Access Compliance Report Public Rights-of-Way (Pedestrian Signals)

Main Street: **BROOKHURST_ST** Cross Street: **ORANGE_AVE** Location: **NW**

ADA ID: **SGRK210927122406** Signal Type: **One Push Button-Non APS** Overall Compliance: **No** Severity Scores: **BTN 1: 25** **BTN 2: N/A** **No BTN: N/A**

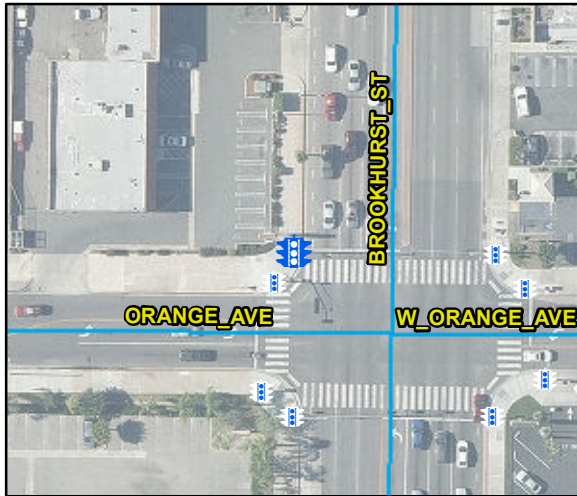
OC Std/PROW: **R404.2**

Possible Solutions: Remove and Replace Clear Space.
